RISOGRAPH
TECHNICAL INFORMATION

SUBJECT: Write Roller, Part Number Change

MODEL: 2700

Issue# T-11

WRITE ROLLER

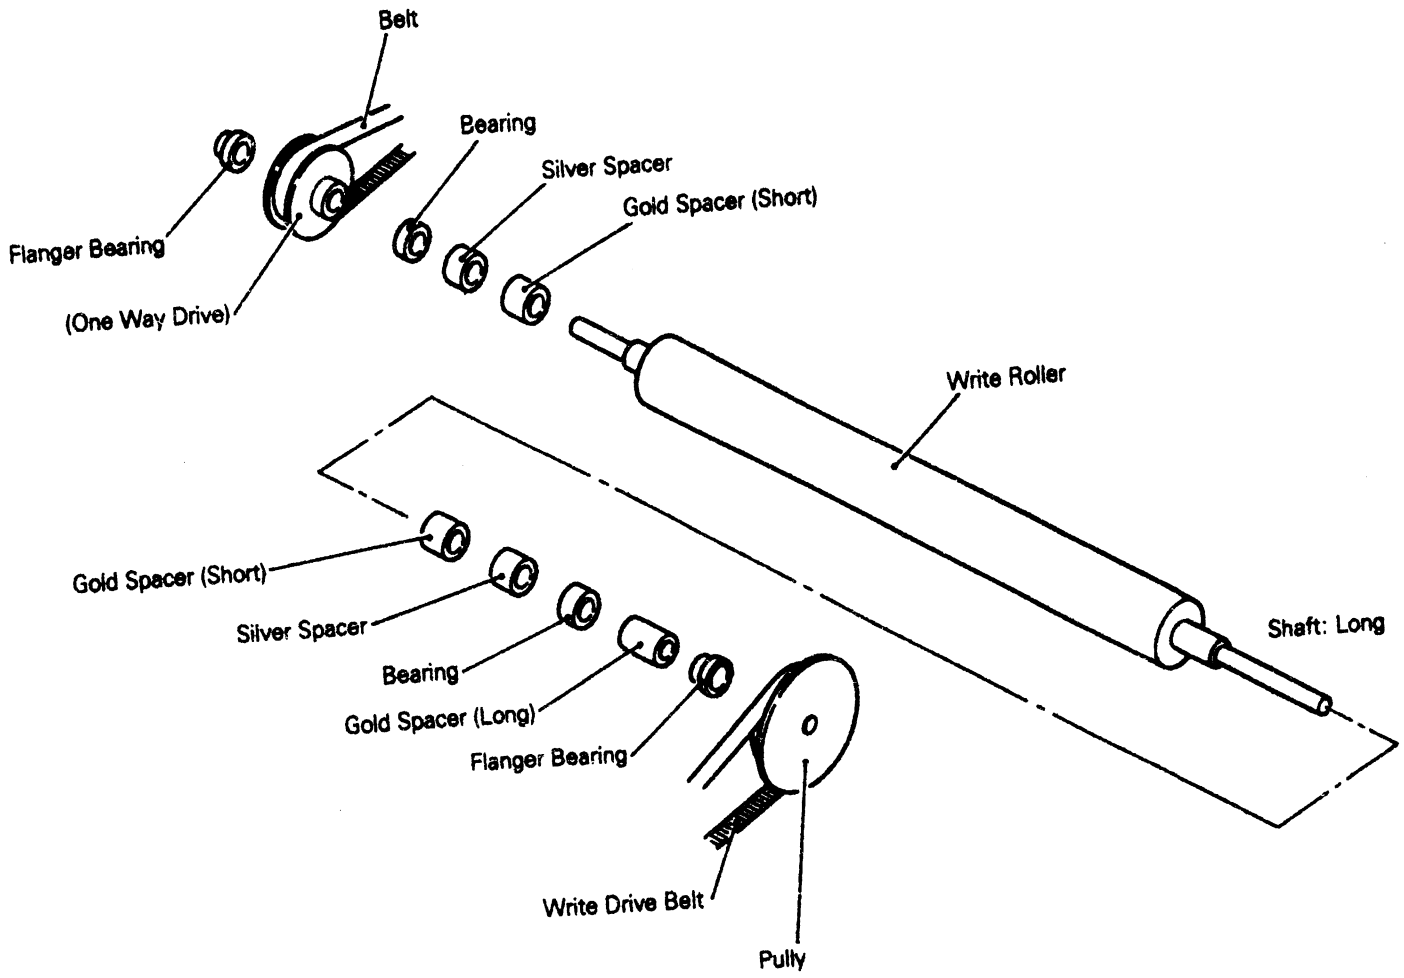
The old part number: 005-21103-000 write roller changed to new part number: 007-15262-104 write roller, price to remain the same.

Reason: Vendor of old write roller changed to new vendor. New type write roller has a different shape.

When changing old type write roller to the new type it will necessary to delete <u>Gold Spacer (Short)</u> during assembly (see figure below).

* Both rollers are interchangable and no modification is needed. However, RISO, Inc. will only carry the new type for replacement stock. Please change your parts list and parts price book to new number.

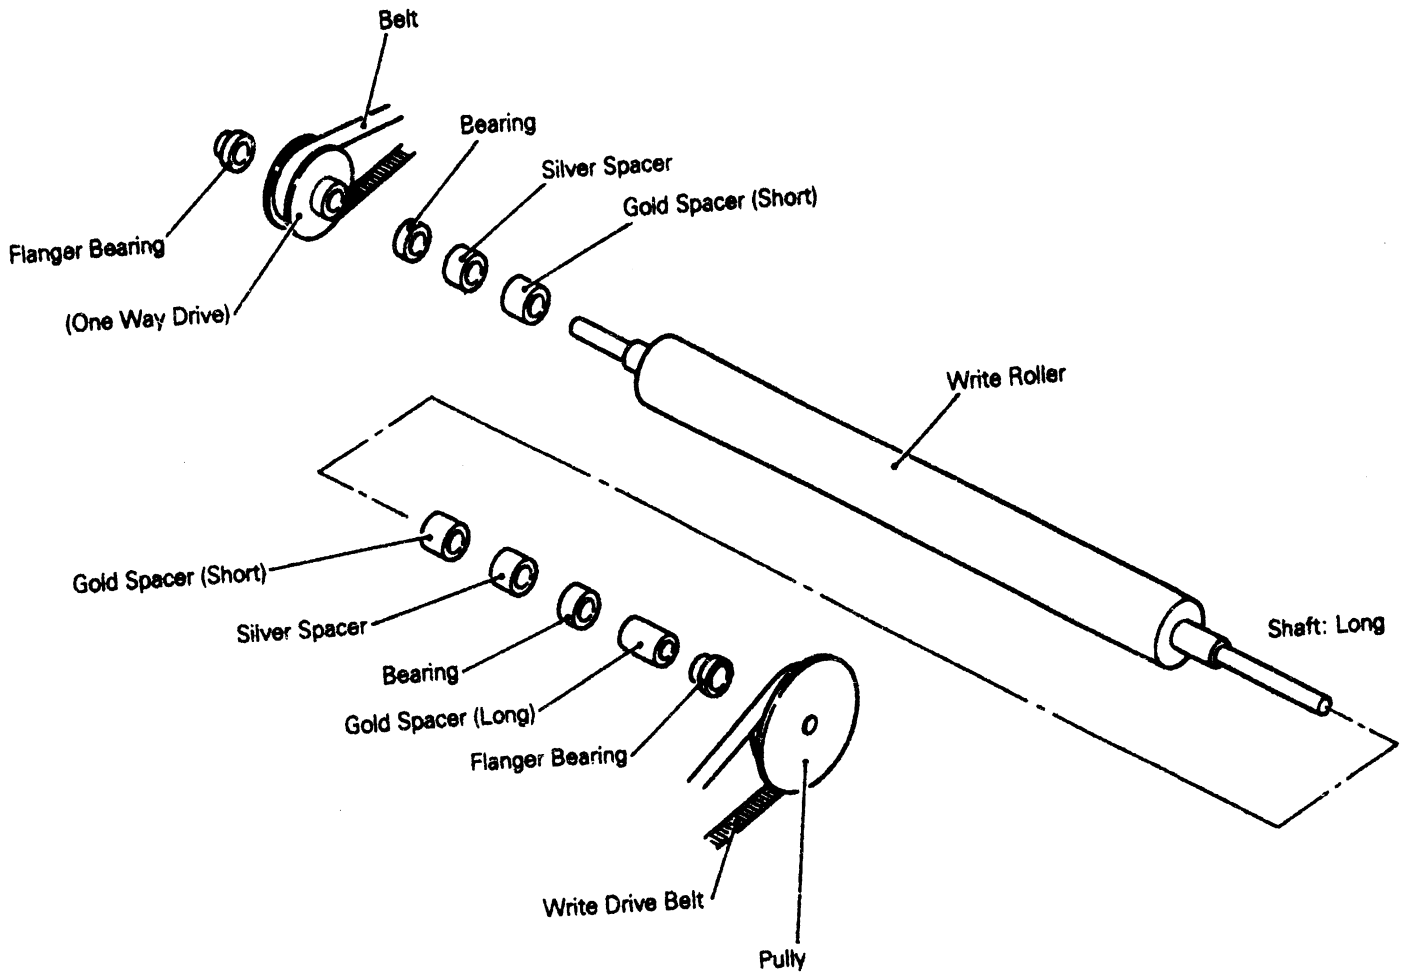
When changing old type write roller to the new type it will necessary to delete <u>Gold Spacer (Short)</u> during assembly (see figure below).
